Status: Y  N  U **Seismic Walkdown Checklist (SWC)**Equipment ID No. 2R43-B002A Equip. Class<sup>1</sup> 21Equipment Description DG 2A LUBE OIL HEAT EXCHLocation: Bldg. DIESEL Floor El. 130 Room, Area 2A

**Seismic Walkdown Checklist (SWC)**

Figure 5 – Cable Raceway near Heat Exchanger (2E11-B001A)

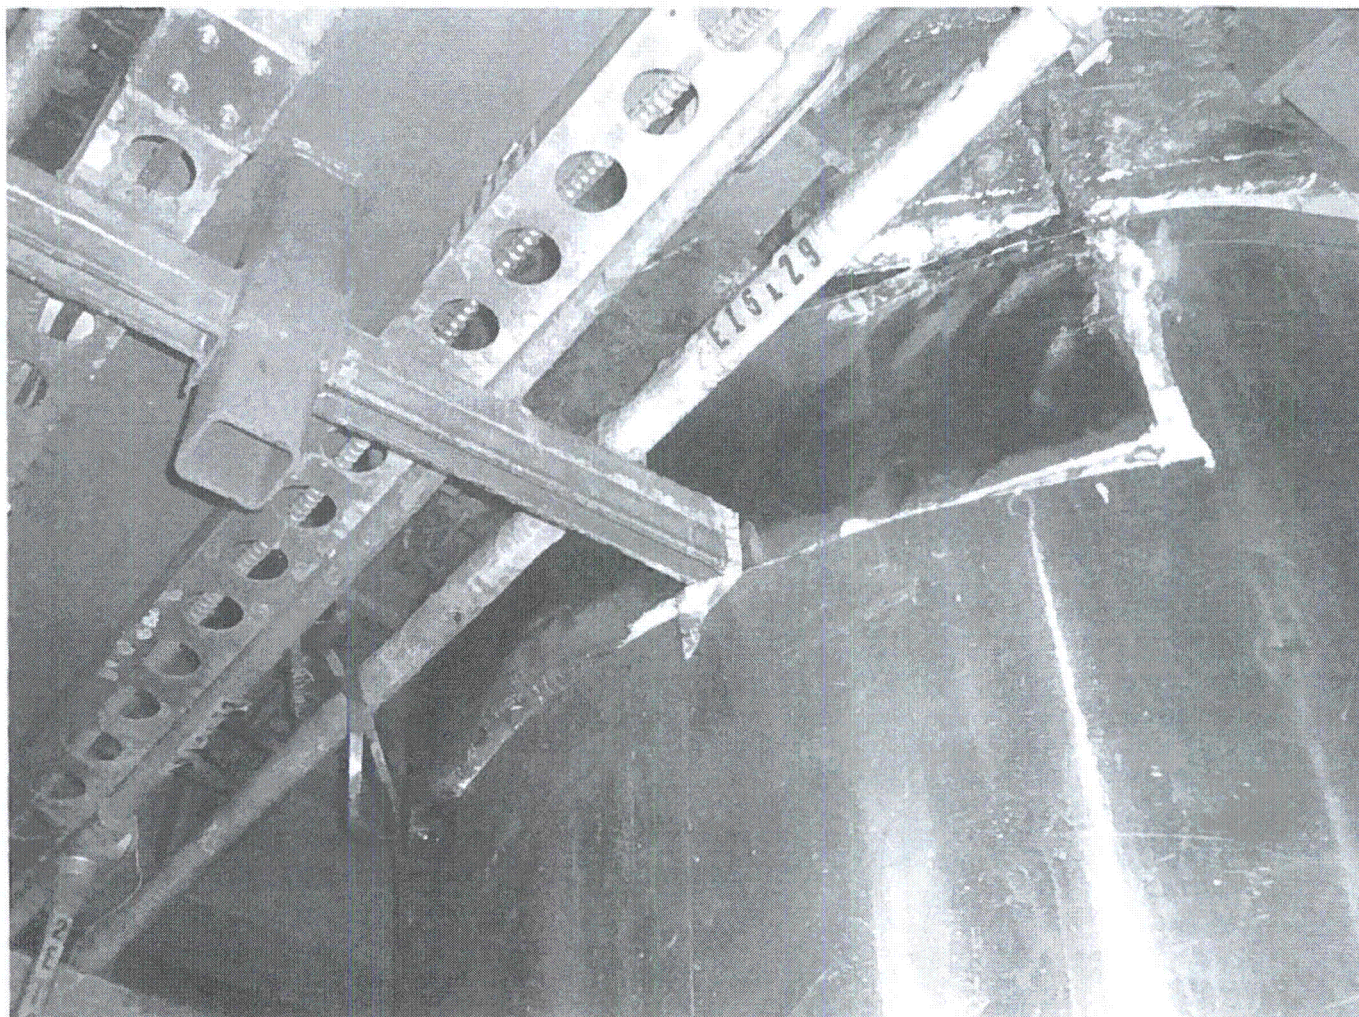
- 10. Based on the above seismic interaction evaluations, is equipment free of potentially adverse seismic interaction effects? Y N U  
*The cable raceway support impinges on the RHR Heat Exchanger insulation, and the insulation has been cut away from the member. The raceway support only impacts the insulation, but is at least one inch from the body of the heat exchanger, so there will be no impact between the two components. Therefore, it is judged that there is no potentially adverse seismic condition.*

Figure 4 – Chipped Bolt Paint (2E11-B001B)

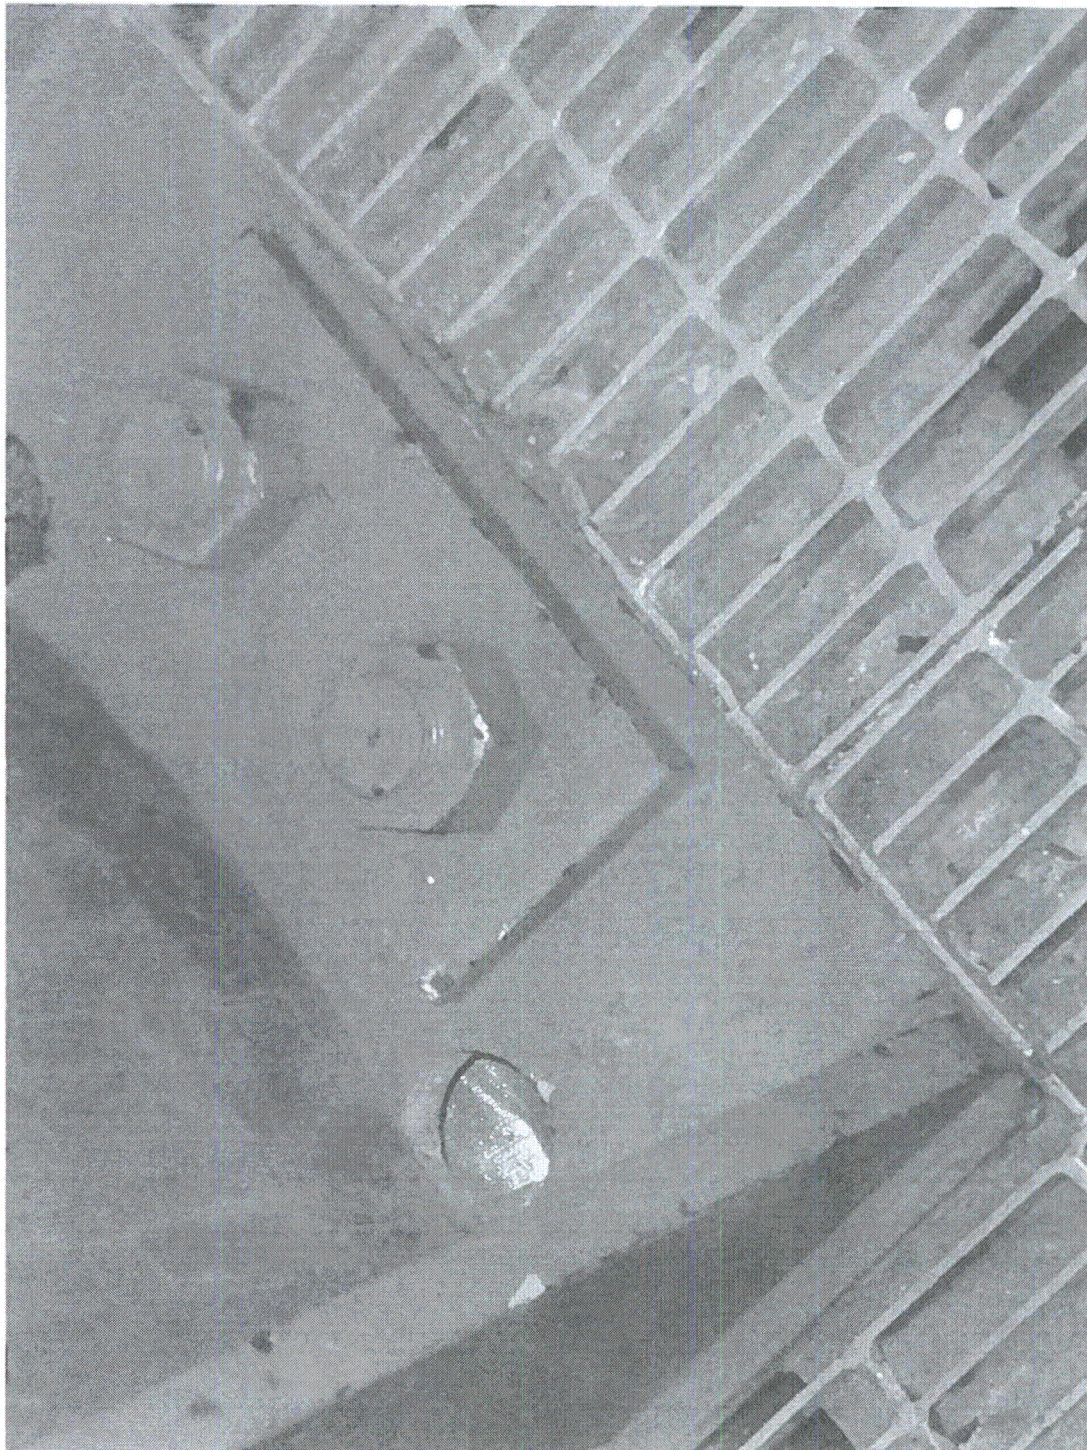
3. Is the anchorage free of corrosion that is more than mild surface oxidation? Y  N  U  N/A   
*The bolt paint chipped off in several places, resulting in mild surface oxidation. Since oxidation is only on the surface, the anchors are not degraded. Therefore, the anchors are judged not be a seismic concern.*

Figure 5 – Conduit Support near Heat Exchanger (2E11-B001B)

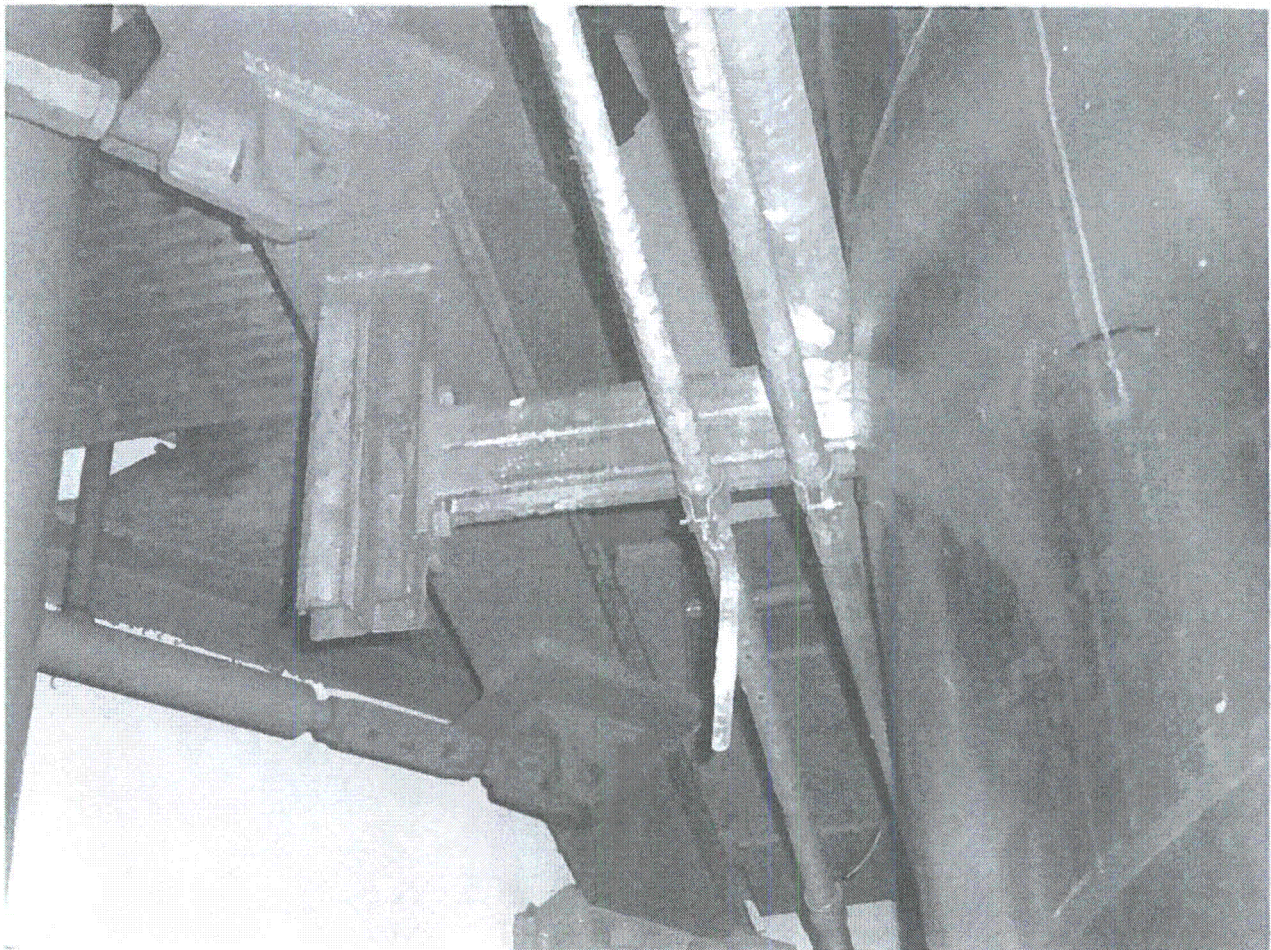
7. Are soft targets free from impact by nearby equipment or structures? Y  N  U  N/A
8. Are overhead equipment, distribution systems, ceiling tiles and lighting, and masonry block walls not likely to collapse onto the equipment? Y  N  U  N/A
9. Do attached lines have adequate flexibility to avoid damage? Y  N  U  N/A
10. Based on the above seismic interaction evaluations, is equipment free of potentially adverse seismic interaction effects? Y  N  U   
*The cable raceway support impinges on the RHR Heat Exchanger insulation, and the insulation has been cut away from the member. The raceway support only impacts the insulation, but is at least one inch from the body of the heat exchanger, so there will be no impact between the two components. Therefore, it is judged that there is no potentially adverse seismic condition.*

Figure 1 Equipment ID (2P70-A002B) No Equipment ID Tag

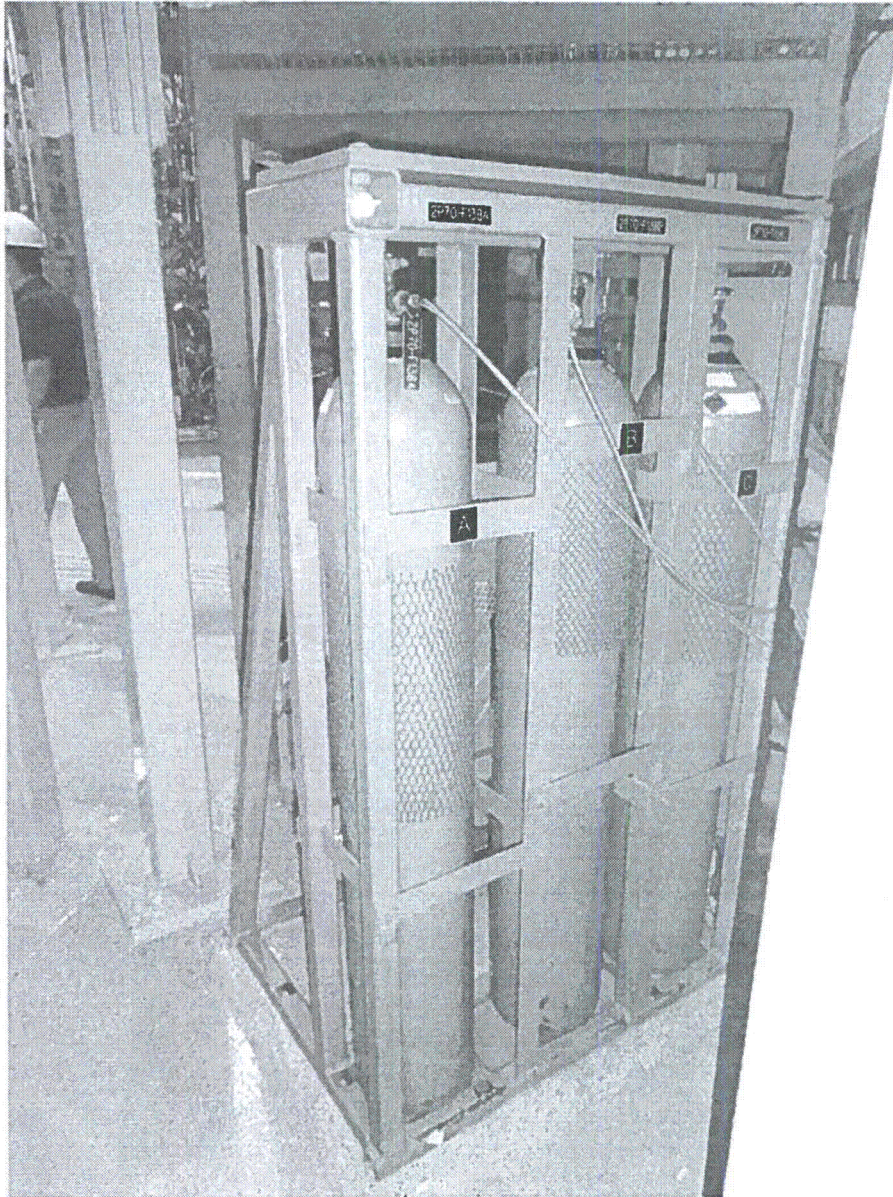
*The rack itself has no MPL number to indicate this is the correct component (See CR 518755). Also, there is a Squeeze Bottle, Wrench and paper stuffed inside the top structural tubes of the rack (see CR 518755)*

Figure 2 Threaded Fastener Located in Anchor Bolt Recess of Rack

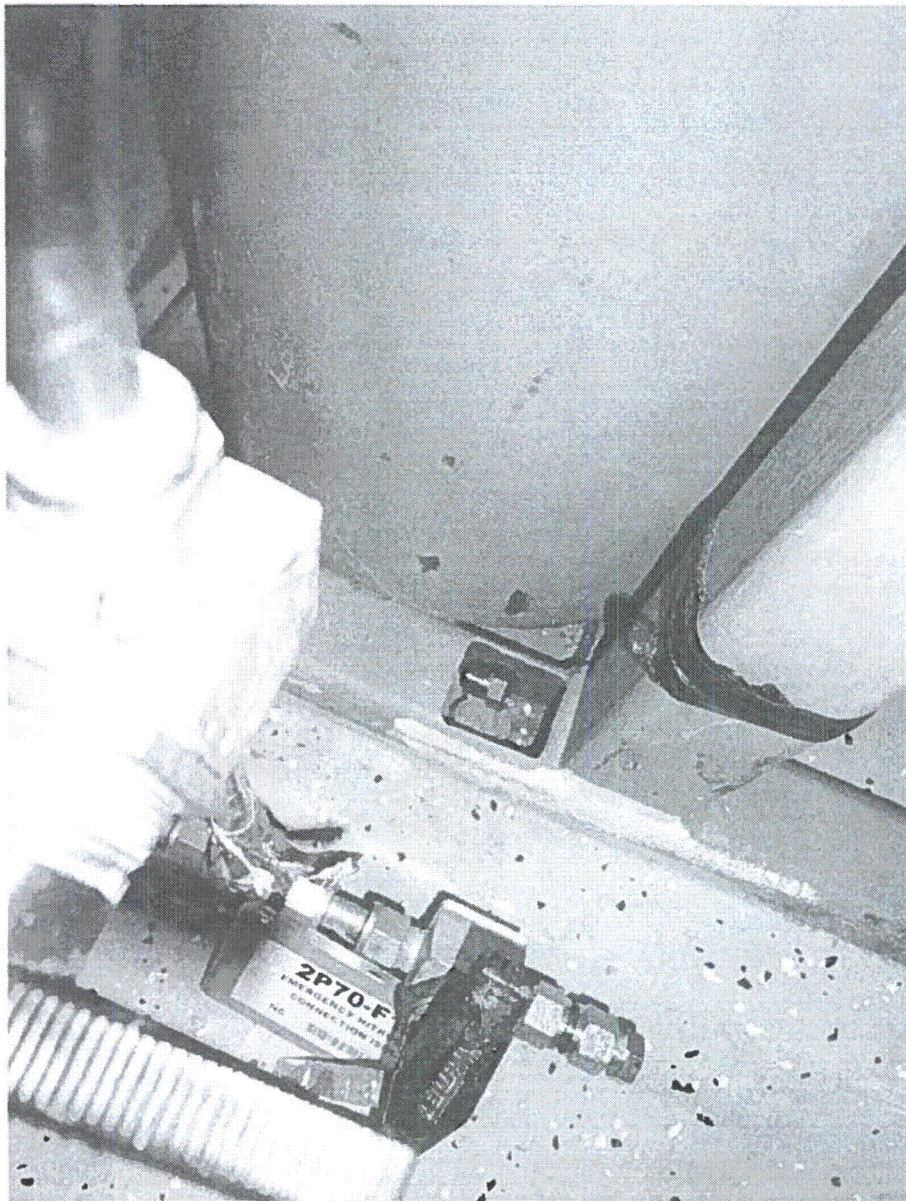
2. Is the anchorage free of bent, broken, missing or loose hardware? Y  N  U  N/A   
*Loose bolt from other component or connection is stuck in the anchor bolt recessed tube area for the anchor. The SWE's have determined that this loose bolt will not damage the rack anchor during a seismic event nor is it likely that the bolt will exit the recessed tube area during a seismic event and damage other equipment. Therefore, the loose bolt at this location is seismically acceptable.*

Figure 3 – Mild Surface Oxidation on Flange Bolts (2G41-F054)

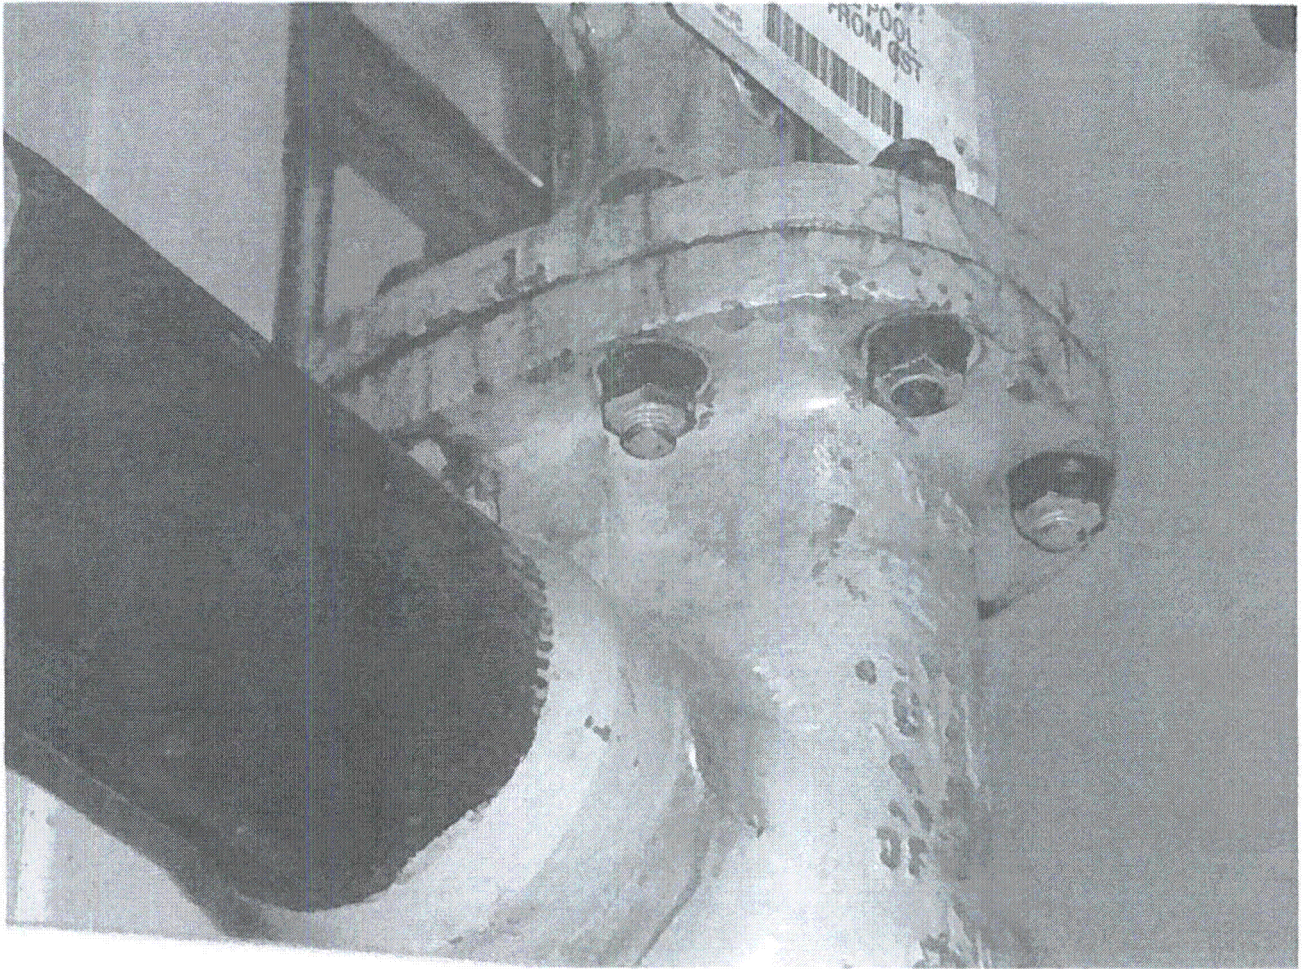
*There is mild surface oxidation on the valve bonnet to body flange bolts. Since oxidation is only on the surface, the flange bolts are not degraded. Therefore, the bolts are judged not be a seismic concern.*

Figure 4 Closely spaced Anchor Bolts

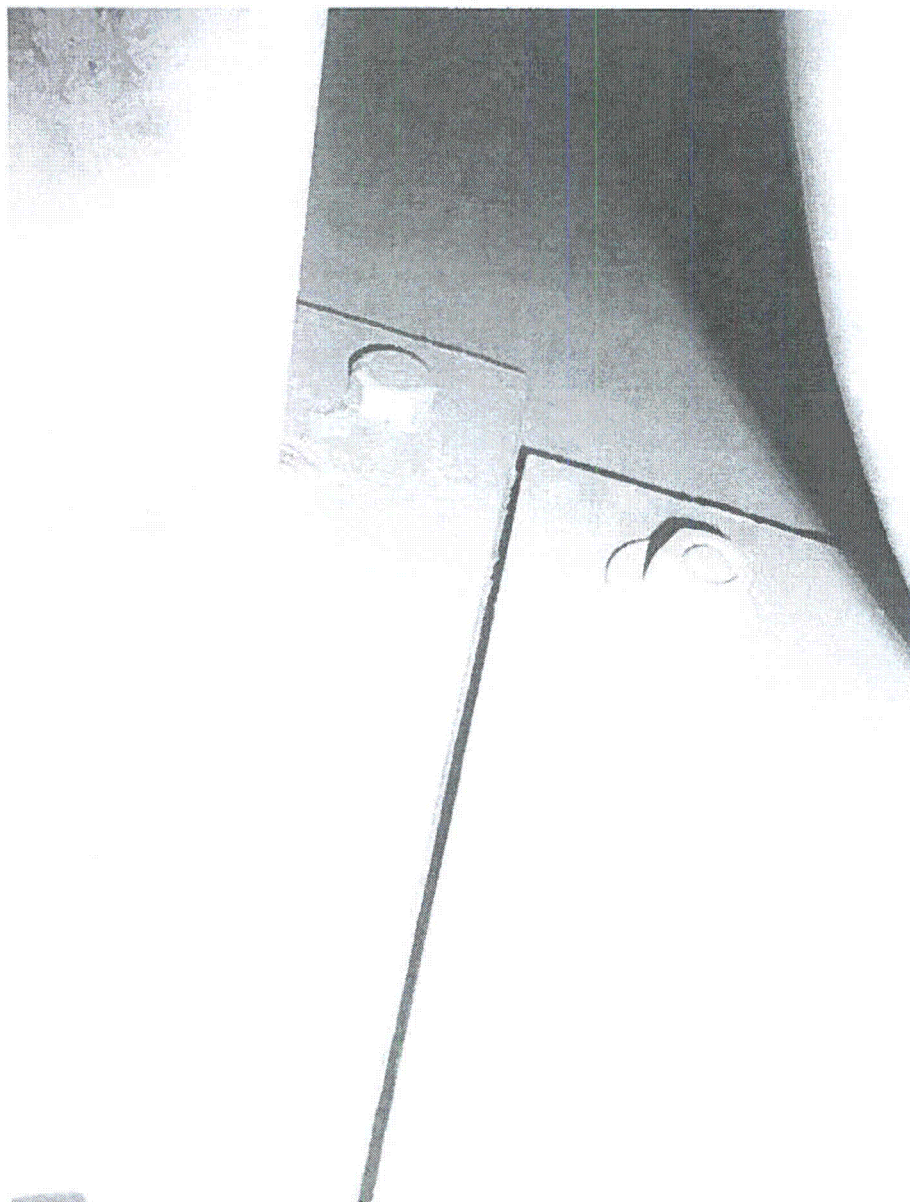
*The component support base-plate anchors are closely spaced to pipe support anchors (See Figure 4 for details). The SWE's have determined that the anchorage is still seismically acceptable with these closely spaced anchors. The component support contains four base-plates with four anchors each. The condition only affects one anchor on one of these plates.*
